Magpie Composite Textile Ltd. (9804)

02.JUN.2014

Identified Priority 1 Concerns

2nd Priority 1 Concern

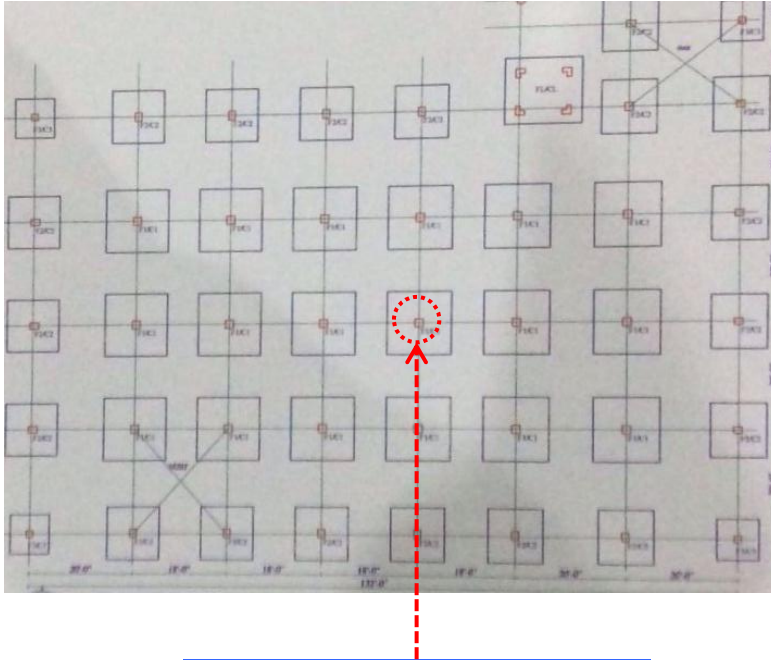
The load due to the storage of carton boxes on level 4 is higher than the design loading of 3.5 kPa (70psf). Each carton box package is estimated to be approximately 22kg with the dimension 0.6x0.4m and 4 layers, so the live load for this area is 3.7kPa (74psf) which is higher than the design loading 3.5kPa (70psf).

The localised live load is higher than the imposed load, the stacking of the boxes should be carefully monitored to ensure that there is no possibility of overloading should loading conditions change in future.

1st Priority 3 Concern

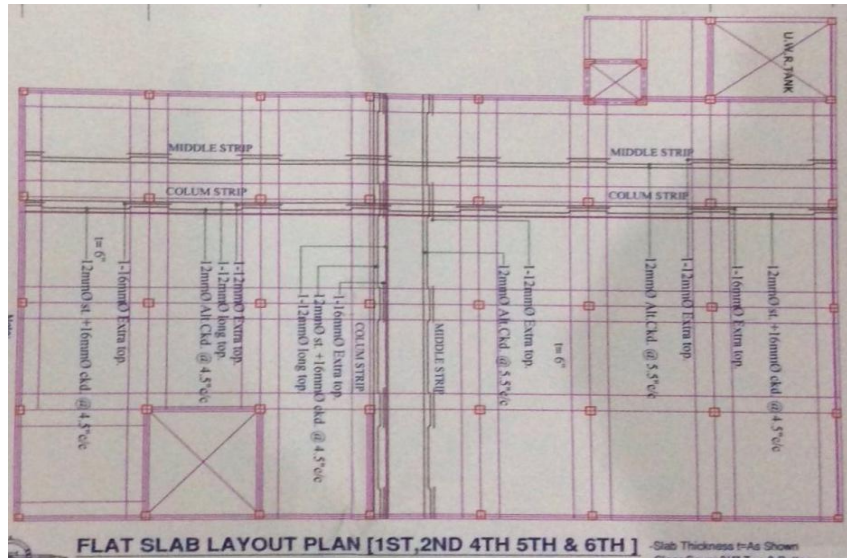
The rafter at this level are missing longitudinal bracing in the roof plane, across one or both end bays of the structure.

Tie rods should be provided in the middle of each purlin span to prevent buckling of the purlin.

Item No.	Observation	Recommended Action Plan	Recommended Timeline
9	1st Priority 3 - The rafter beams in the roof of main building are missing their longitudinal bracing in the roof. No tie rods have been provided for the purlins at the mid-span between trusses.	The bracing system needs to be provided in the longitudinal direction and a tie rod needs to be provided to the purlins at mid-span.	6-months
10	2nd Priority 3 - No lateral load resistance system in the main building.	Building engineer to check and provide the solution for lateral resisting requirements of the structure.	6-weeks
11	2nd Priority 3 - No lateral load resistance system in the main building.	As per the results of structural analysis, the building needs to be revised to accord with BNBC building codes with regard to lateral stability.	6-months
12	3rd Priority 3 - Dyeing section - The rafters are missing their longitudinal bracing in the roof. The steel columns are also missing the vertical bracing in the elevations. No tie rods have been provided for the purlins at their mid-span.	The bracing system need to be provided in the longitudinal direction in the roof and for the columns. The purlins need to provided with tie rods in their mid-span.	6-months

5th Priority 3 Concern

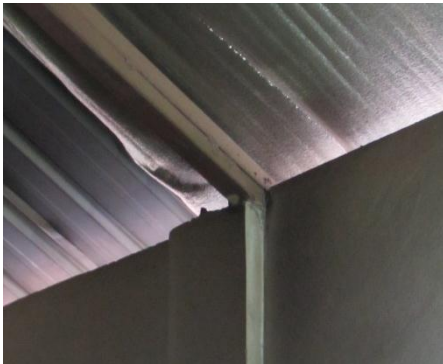
Generator room

This type of structural building appears to be a temporary structure.

The steel beams of the roof are very small with very simple connections and appear to be corroded and have excessive deflections.

We require that these items be investigated in a Detailed Engineering Assessment.
